# ASSESSMENT REPORT

## Section 75W Modification Eastern Creek Waste Facility (06\_0239 MOD 1)

**Figure 3: Proposed Modification Components**

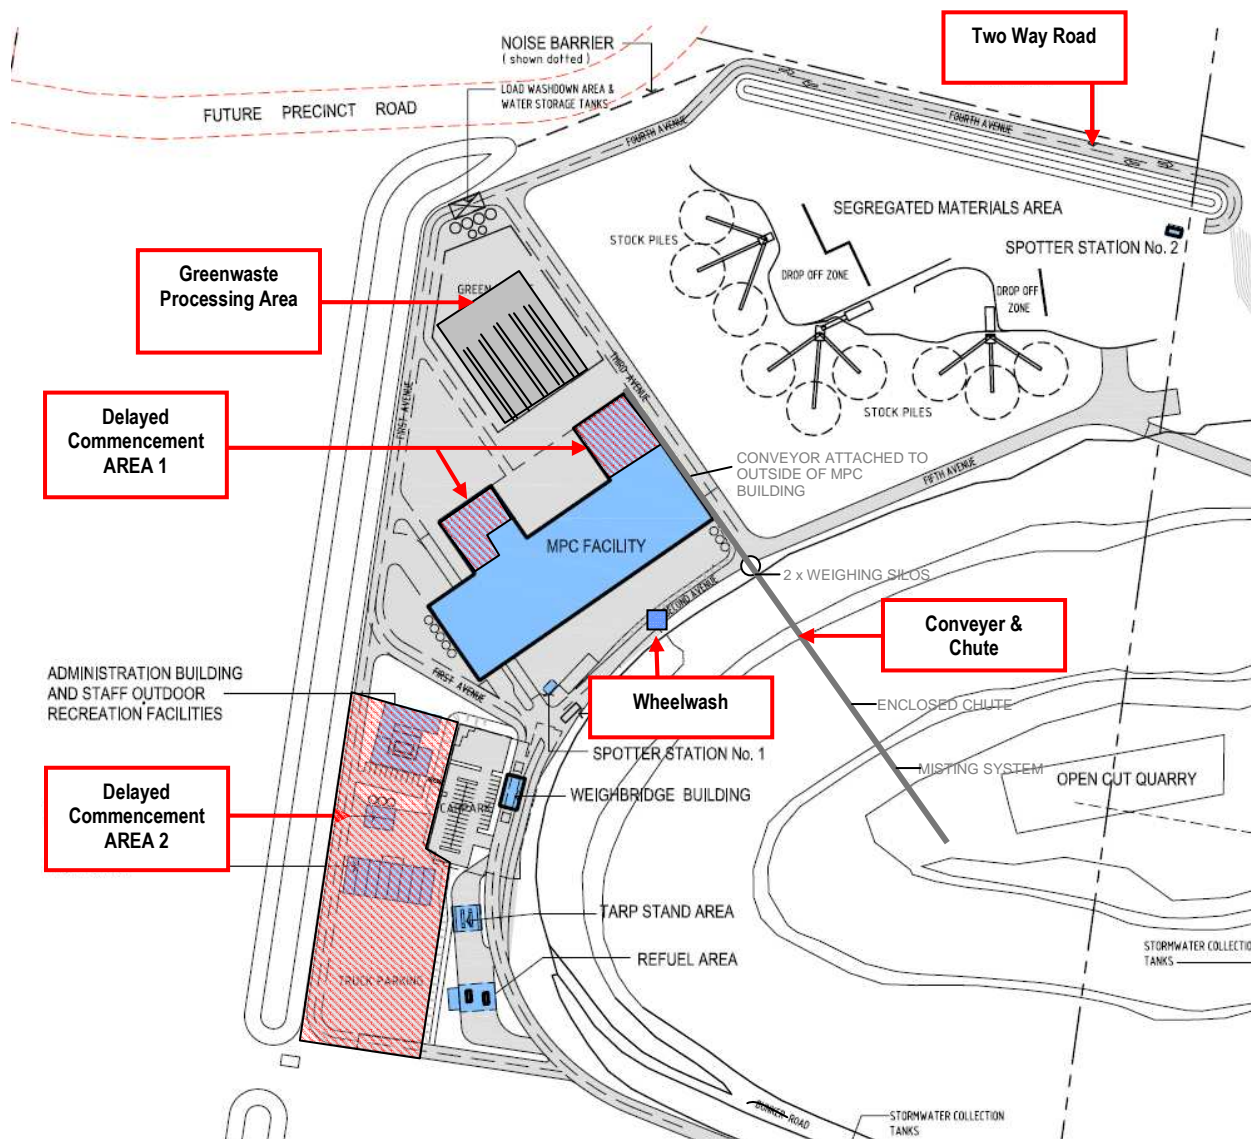
Component	Description
1	<p><b>Electrically Powered Conveyor and Chute</b></p> <ul style="list-style-type: none"> <li>▪ As part of the approved project, waste would be transferred to the base of the quarry pit by dump truck winding down a 3.8 kilometre haulroad.</li> <li>▪ ThaQuarry now propose to construct an electrically powered conveyor and chute for the conveyance of waste directly from the MPC to the base of the landfill.</li> <li>▪ Waste would be transported by an enclosed conveyor directly from a loading hopper within the MPC to the quarry lip passing under the road via a culvert. The waste would enter one of two 10 m<sup>3</sup> weighing silos located side by side. The silos would replace weighbridge 2. When a silo reaches its maximum weight, a weight sensor would trigger the silo to open and gradually feed the waste onto the electrically powered downhill conveyor. The waste would then proceed via conveyor to the mid point of the quarry and be transferred to an enclosed chute which travels to within 6 metres of the quarry base. A canvas sock at the base of the chute would ensure that the actual drop height between the end of the sock and the base of the quarry would be no more than 3 metres.</li> <li>▪ The discharge end of the chute would be equipped with fine mist sprays to minimise dust and the plant would be routinely maintained. However, in the unlikely event of plant failure, waste would be trucked to the base of the quarry in accordance with the current approval.</li> <li>▪ Asbestos waste would be separated prior to it entering the MPC building, bagged and trucked to the base of the quarry for burial.</li> </ul>

2	<p><b>Postponed Commencement of Construction</b></p> <ul style="list-style-type: none"> <li>▪ ThaQuarry proposes to postpone construction of redundant sections of the MPC building (Area 1), the Administration Building; Outdoor Recreation Facility, Washbay, Workshop and Truck Parking area (Area 2) until after commencement of operations.</li> <li>▪ Area 1 - ThaQuarry seeks to reconfigure the internal waste handling operations within the MPC building to accommodate the installation of an automated materials handling process (refer Component 1).</li> <li>▪ This automated process does not require the amount of covered floor space that would otherwise be required for manual sorting and therefore renders the area identified as Area 1 in Figure 3 as redundant.</li> <li>▪ Area 2 - ThaQuarry seek to postpone the commencement of the construction of a number of ancillary structures identified in Area 2 in Figure 3.</li> </ul>

3	<p><b>Two Way Traffic on Fourth Avenue</b></p> <ul style="list-style-type: none"> <li>▪ Fourth Avenue, located to the north of the site, is a roadway 8 metres wide approved to cater for one-way vehicle traffic movements.</li> <li>▪ ThaQuarry seeks to modify the project approval to enable this roadway to cater for two-way vehicle movements as depicted in Figure 3.</li> </ul>
4	<p><b>Concrete Bay Walls within the Greenwaste Processing Area</b></p> <ul style="list-style-type: none"> <li>▪ Construct concrete bay walls within the greenwaste processing area. Each bay would be individually covered and fitted with aerobic equipment.</li> </ul>
5	<p><b>Relocation of Wheelwash</b></p> <ul style="list-style-type: none"> <li>▪ ThaQuarry propose to relocate an approved drive through wheelwash 100 metres to the north along Second Avenue. This presents a better location in terms of the operation and management of the facility.</li> <li>▪ The relocation of the wheelwash would minimise the distance travelled with material build up on tyres which in turn would improve dust management and general cleanliness of the site.</li> </ul>

Council generally supported the project. However, concerns were raised in relation to noise associated with the conveyor/chute and issues associated with the postponed commencement of certain structures. Council requested that a number of conditions addressing these issue be included in the consent should the modification be approved.

The DECCW supported the proposed modification. However, they requested additional information regarding the conveyor/chute system and recommended a number of condition to be included in the consent should the modification be approved.

Both Council, the DECCW raised concerns that the proposed electrically powered conveyor/chute system has the potential to increase noise impacts from the site.

Based on the information provided, the Department and the DECCW consider that the proposed modification would not result in additional noise impacts from those already assessed. The Department considers that potential noise impacts associated with the modification would largely be managed through existing conditions of approval including noise limits and monitoring. Notwithstanding, recommended conditions require the Proponent to:

- ensure that the operating hours of the conveyor/chute system are restricted to the facility's operational hours.

Notwithstanding, the Department has recommended conditions of approval that require the Proponent to:

- ensure that the conveyor/chute system is fully enclosed;
- ensure that the waste drop height of no more than 3 metres between the end of the sock and the base of the quarry;
- incorporate fine mist sprays at the discharge end of the chute to minimise dust;
- prepare a conveyor/chute system maintenance and management plan that includes a maintenance schedule;
- detail contingency measures in the event that the system breaks down, or is not coping with the intended quantities of waste; and
- ensure that each greenwaste bay has an individual cover and anaerobic equipment fitted to reduce odour and the generation of leachate.
